<b>Docket Number:</b>	19-BSTD-03
<b>Project Title:</b>	2022 Energy Code Pre-Rulemaking
<b>TN #:</b>	236942
<b>Document Title:</b>	SDG&E Comments on AB 2127 Draft Report
<b>Description:</b>	N/A
<b>Filer:</b>	System
<b>Organization:</b>	Jaron Weston
<b>Submitter Role:</b>	Public
<b>Submission Date:</b>	2/26/2021 5:08:25 PM
<b>Docketed Date:</b>	3/1/2021

**SDG&E Comments on AB 2127 Draft Report**

Re: San Diego Gas & Electric Comments on AB 2127 Electric Vehicle Charging Infrastructure Assessment

**AB 2127 Report: Projected 2030 PEV Load Forecast, Page 33**

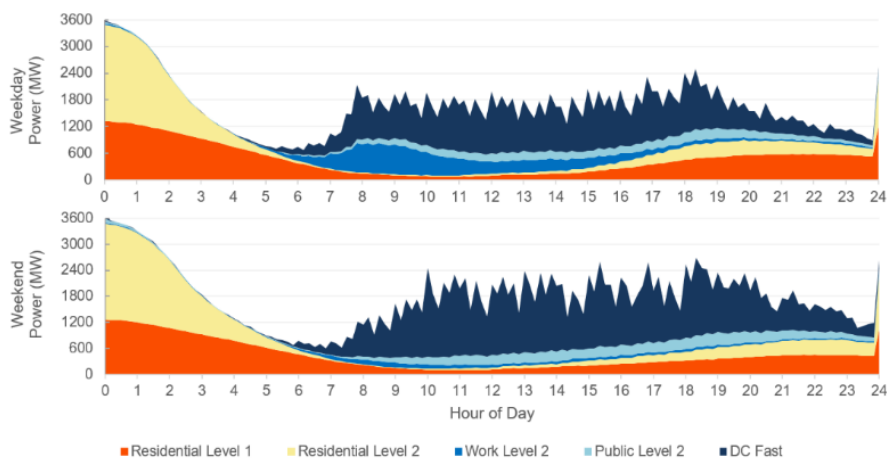
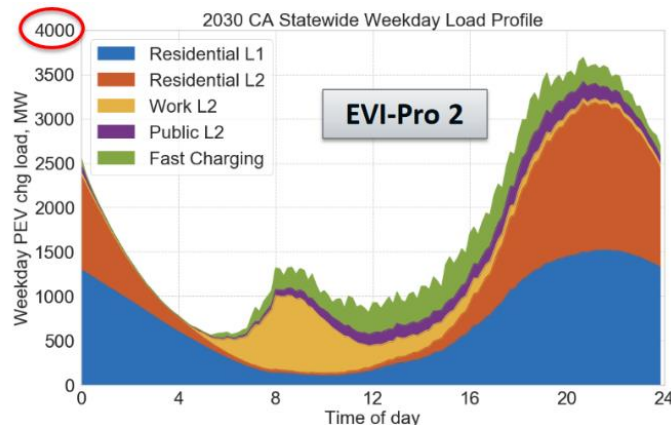
**The CEC should include clearer and stronger identification of the variability of load impacts from modeling results**

Figure 14 of the AB 2127 Assessment updates a tremendously critical analysis that the CEC has pioneered and led for years on forecasted load impacts of plug-in electric vehicle (PEV) charging. The iteration featured in the present AB 2127 Assessment unveils significant and exciting updates from previous iterations. Most notably, the overall load shape has shifted, with peak moving from roughly 8 pm to midnight. Further, the bi-modal second peak, at roughly 8 am, is no longer present. (See figures below for reference.) As noted in the AB 2127 Assessment, this underscores the importance of the innovative rates passed by SDG&E and other utilities.

The fact that there are such updates to the forecasted load impacts reflects two important characteristics: (1) the industry's understanding of charging behavior is just as nascent as the market itself and (2) charging behavior is subject to meaningful changes based on market developments. Accordingly, SDG&E suggests contextualizing this analysis to show how estimates have changed over time. The load forecasts will inherently communicate that significant adaptation is necessary to support charging infrastructure without any context. However, by providing proper context, the broader audience will understand that continual market analysis and appropriate policy support, such as utility rates, can (and have) positively influenced charging behavior.
